INFORMATION BULLETIN

Differential Air Pressure Switches

Sentinel and Oval 80 Radiant heaters.

Fig. 1

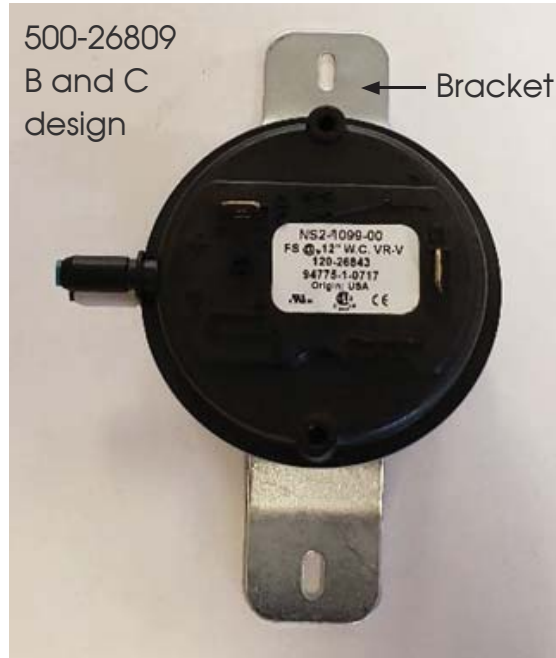
Part number 500-26809:

Used on: Oval 80 B and C design , and Sentinel C design heaters.
(ex: AR080BSPD120121, AT125CSPS210141)

Location: Burner side of the burner box partition panel.

Appearance: Has a mounting bracket and will always have a white label.
See Fig. 1 and 2 below.

Fig. 3

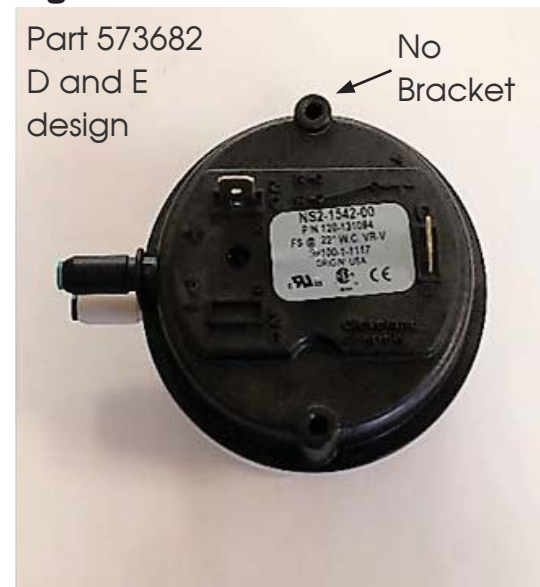
Part 573682:

Used on: Oval 80 and Sentinel D and E design heaters.
(ex: AR080D2PD12160B, AT125E4PD12161B)

Location: Motor side of the burner box partition panel

Appearance: No mounting bracket. Also has a label identifying pressure of .22 " W.C.

THE SWITCHES ARE NOT INTERCHANGEABLE. You must use the specific switch for the heater's design sequence and its location within the burner box. The set points are different between the switches. The switches are available for purchase by contacting L.B. White Company, LLC at 1-800-345-7200.
